# INTERNATIONAL BOUNDARY AND WATER COMMISSION UNITED STATES AND MEXICO

April 30, 2024

**Subject:** International Boundary and Water Commission, United States Section (USIBWC) Requirements for Construction in the Rio Grande Floodplain – Fronton Island, Start County, Texas

## **Exhibit 2: Photos**

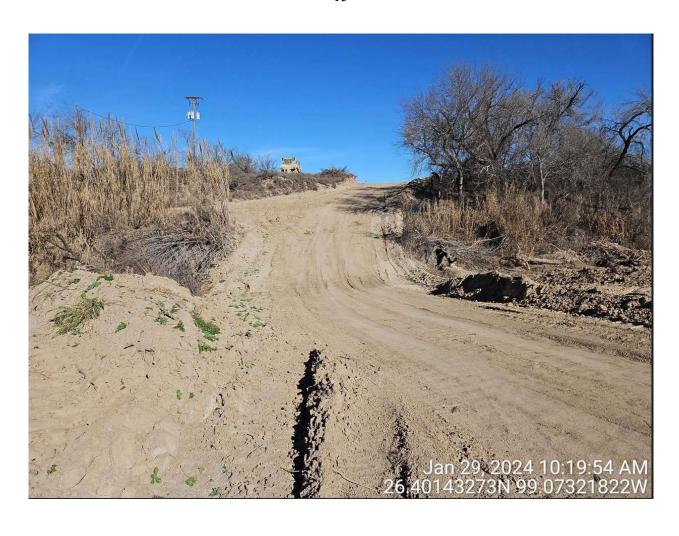
During a field visit on January 29, 2024, USIBWC staff noticed two land bridges to the island, cleared vegetation, and a line of concertina wire fence along the southern boundary of the island. The west land bridge is located at 26° 23' 53.89" N and 99° 04' 42.01" W and the east land bridge at 26° 24' 5.63" N and 99° 04' 23.86" W. The land bridges were constructed by placing fill in the river channel to connect the north bank of the river to the island. Hydraulic modeling documented in the 'Lower Rio Grande Valley from Falcon Dam to Peñitas, Programmatic Floodplain Analysis

In regard to the unapproved constructed works, the constructed land bridges, and the installed concertina fence (as described above) block the portion of flow that would normally occur in the small river channel along the northern bank of Fronton Island during normal and design flood events and could potentially cause deflection of the river flow towards Mexico, in violation of the 1970 Treaty. Another concern is potential debris that may be trapped along the concertina wire fence that has the potential to also cause flow deflection toward Mexico. This could be particularly harmful in flood conditions where this situation may promote unanticipated flooding in Mexico and the surrounding area.

We respectfully request that the Texas General Land Office direct the removal of the obstructions and reestablish the flow in the existing channel north of the island. We would also like to emphasize that hydraulic modeling and analysis for hydraulic impacts be conducted in advance of these kinds of projects. Both the U.S. and Mexican Sections review the modeling and ensure that the hydraulic impacts are minor and consistent with the 1970 Treaty before work may be accomplished. We respectfully request that the Texas General Land Office notify us within seven days of receipt of this letter of a plan and schedule on when the site will be returned to pre-construction conditions, reestablishing the previous ability for water flow into the existing channel north of the island and for removing the installed obstructions such as the concertina wire fence.

Exhibit 3: Rio Grande Floodplain (Adapted from Figure A5 of Baker, 2019)

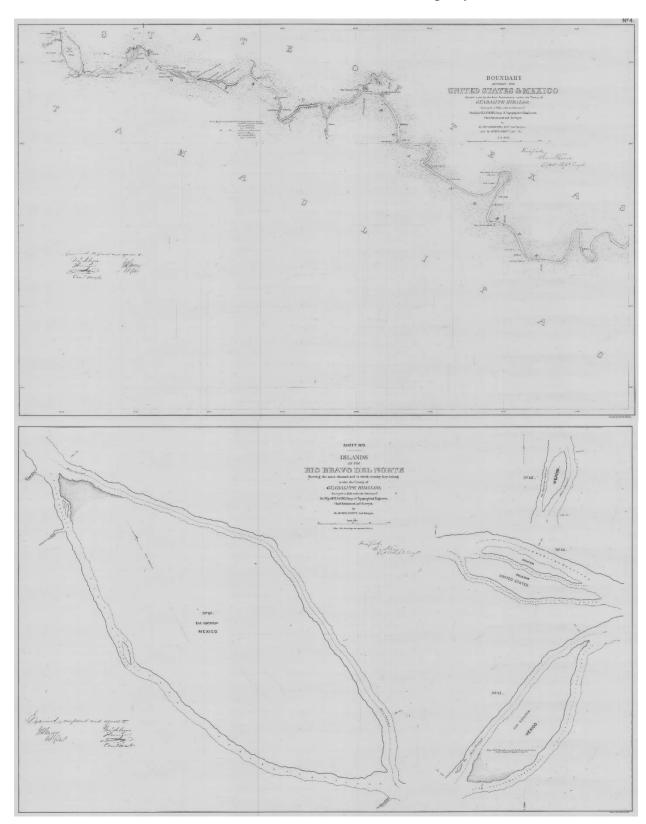
and Report' of February 5, 2019, prepared by Michael Baker International for the U.S. Army Corps of Engineers (USACE), Fort Worth District, Texas (**Exhibit 3**) shows that Fronton Island is within the floodplain of the Rio Grande and thus within USIBWC jurisdiction in accordance with the 1970 Treaty and as such requires USIBWC involvement and coordination on any proposed work.
